MIL "ON" DTC P2820

Service Category Drivetrain

Section CVT

YEAR(S)	MODEL(S)	ADDITIONAL INFORMATION
2016	iM	Transmission(s): CVT

Figure 1. Location of Authorized Modifications Label for 2016 iM

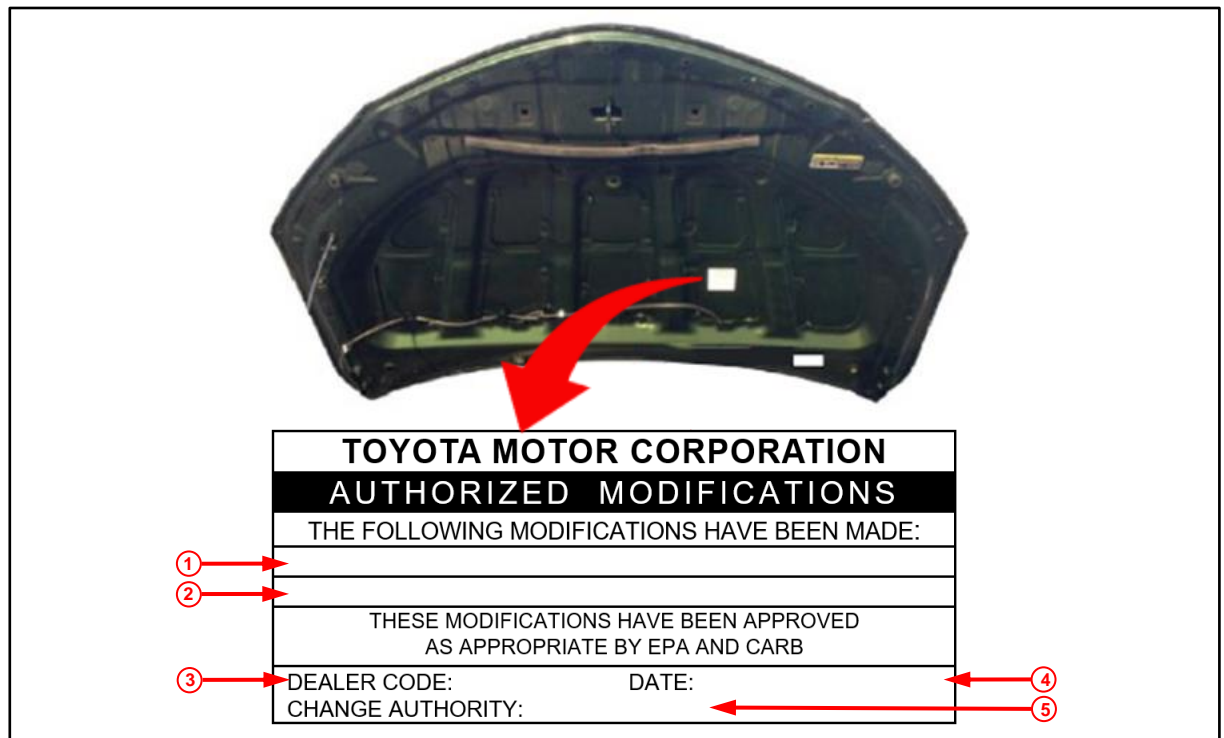
- Check for the Authorized Modifications Label affixed to the vehicle in the location shown below. Confirm if the ECM (PCM) calibration has been updated.

6. Prepare and install the Authorized Modifications Label.
 - A. Using a permanent marker, enter the following information on the label:
 - ECM part number [Refer to the **Parts Information** section for the **NEW PART NUMBER**]
 - Calibration ID(s) [Refer to the **Calibration Information** section for the **NEW CALIBRATION ID**]
 - Dealer Code
 - Repair Date
 - Change Authority [**This bulletin number**]
 - B. Install the Authorized Modifications Label on the vehicle at the location shown in Figure 1. The Authorized Modifications Label is available through the MDC, P/N 00451-00001-LBL.
7. Perform the Techstream ECT Reset Memory Utility.
8. Test drive the vehicle to confirm the repair.
